**From:** Bob Pagliuco - NOAA Affiliate <bob.pagliuco@noaa.gov>  
**Sent:** Saturday, April 09, 2016 12:42 AM  
**To:** Murano, Taro@Waterboards; Anderson, Skyler@Waterboards  
**Subject:** Fwd: 40710 Stanshaw Creek II Additional Funding Request  
**Attachments:** Marble Mountain Pipeline.pdf; 40710 Revised SOW for Additional Funds\_Task 6 Revision.pdf

**Subject:** 40710 Stanshaw Creek II Additional Funding Request  
**To:** "Bean, Caitlin@Wildlife" <[Caitlin.Bean@wildlife.ca.gov](mailto:Caitlin.Bean@wildlife.ca.gov)>, "Bull, Jennifer@Wildlife" <[Jennifer.Bull@wildlife.ca.gov](mailto:Jennifer.Bull@wildlife.ca.gov)>, "Ebert, Demian ([Demian.Ebert@pacificorp.com](mailto:Demian.Ebert@pacificorp.com))" <[Demian.Ebert@pacificorp.com](mailto:Demian.Ebert@pacificorp.com)>, Bob Pagliuco - NOAA Affiliate <[bob.pagliuco@noaa.gov](mailto:bob.pagliuco@noaa.gov)>

## **Revised Scope of Work for Stanshaw Creek Water Conservation Assessment – Phase II**

**Marble Mountain Ranch**  
**Water Efficiency Study**  
 Plan View

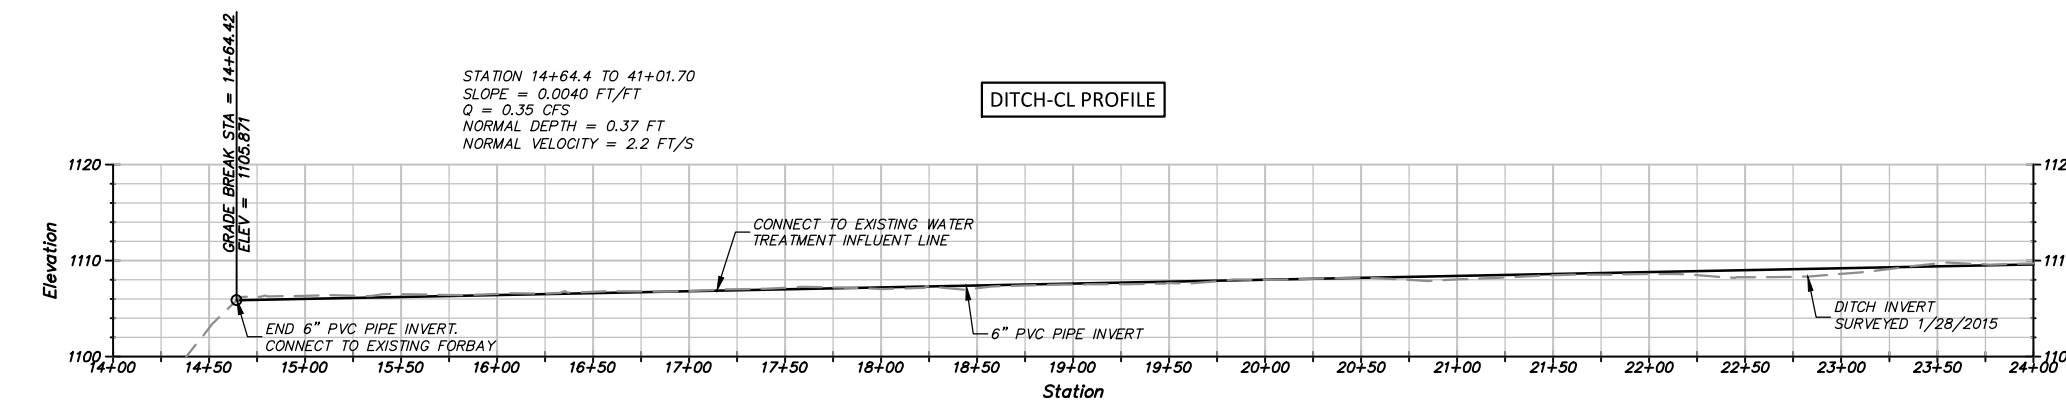
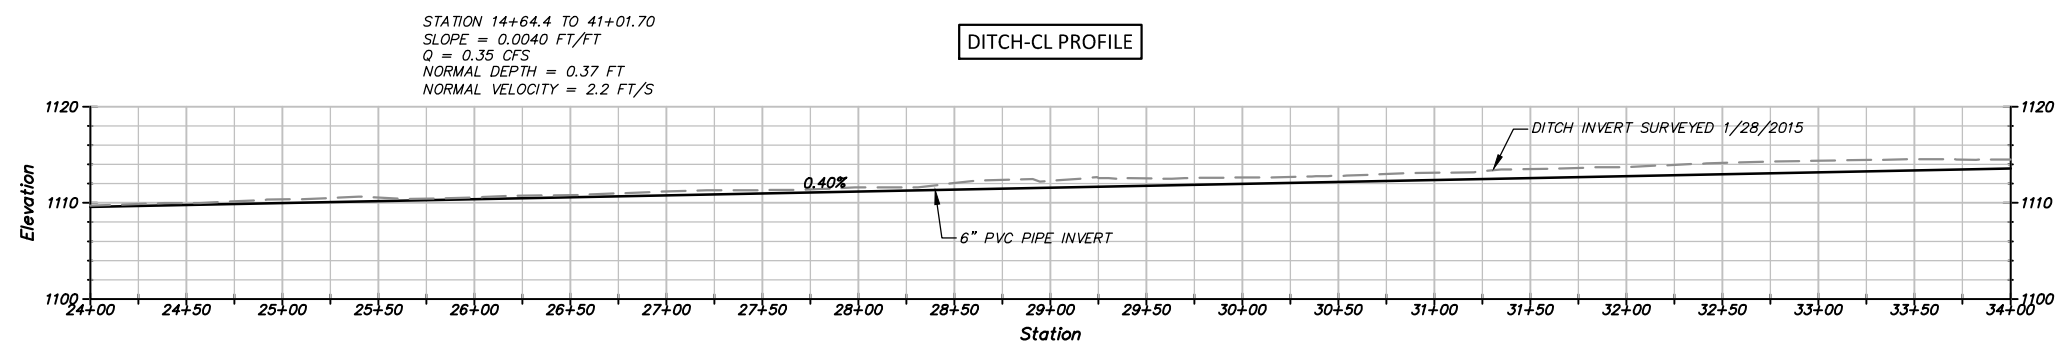
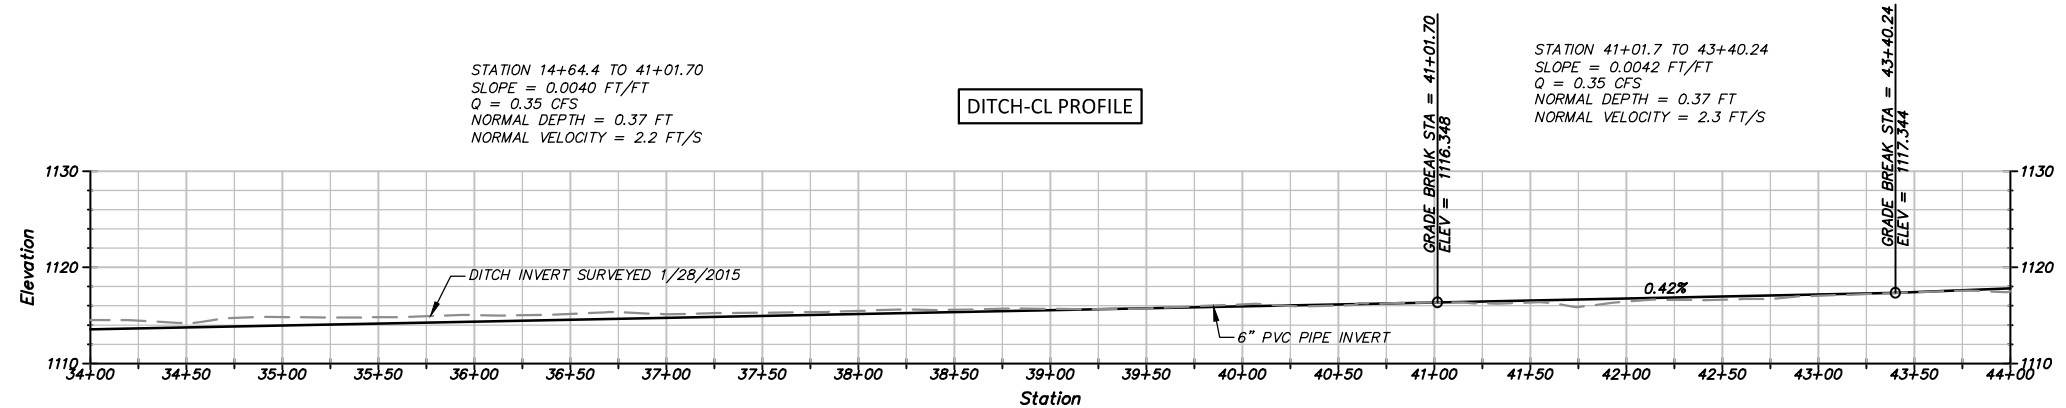
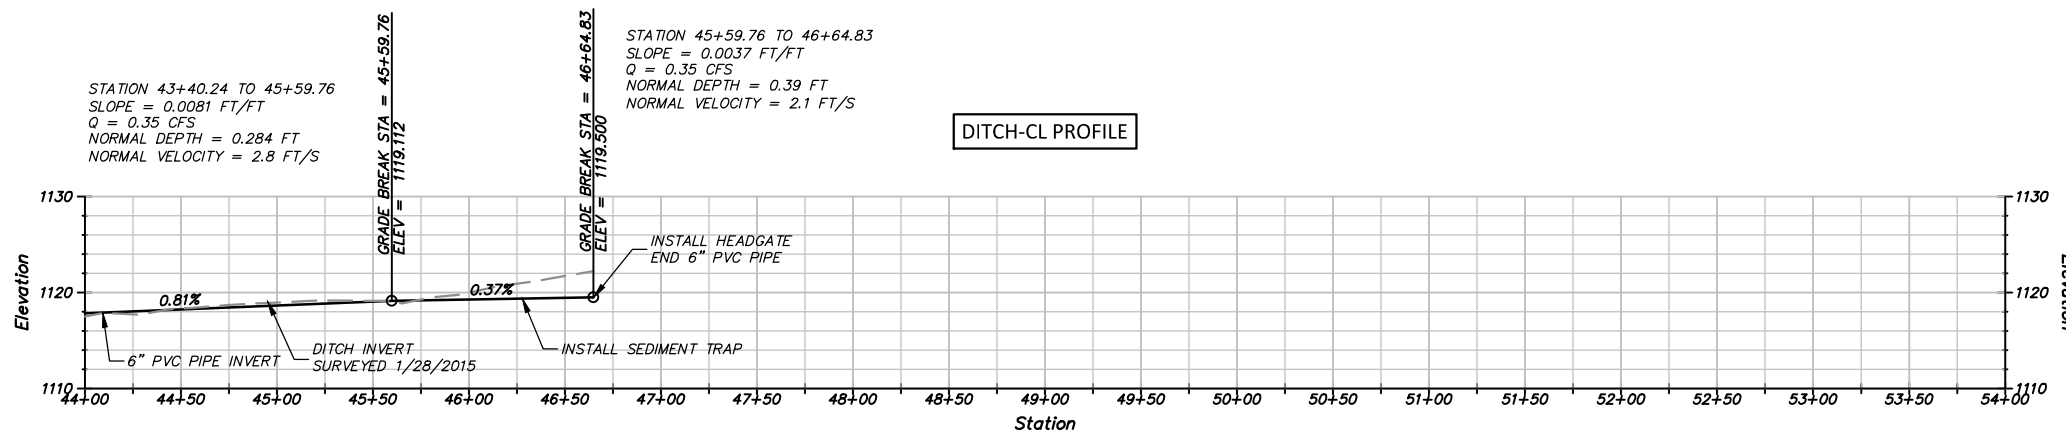
### 1. Can you send the most recent pipeline design?

1. Can you send the most recent pipeline design?
2. Your budget asks for \$32,467 for the pipeline at the bottom (highlighted) but the materials up top in the line items add up to \$27,090 (highlighted). What is your additional request from CEF? What is the landowner going to cost share on the pipe? What has the landowner already put in to the Stanshaw project thus far in matching funds?

Will Harling: Yes, as soon as Joey completes it. Basically so far he has the distance and the flow calcs. What level of design are you anticipating? I can send you the design calcs we sent to Margaret Tauzer.

Joey Howard: I prepared an initial design for Margaret Tauzer review (attached). I believe the pipeline can be constructed from this plan. However, I intend to add additional detail on the trench and headgate. So, I'd say we are near a 70% design level.
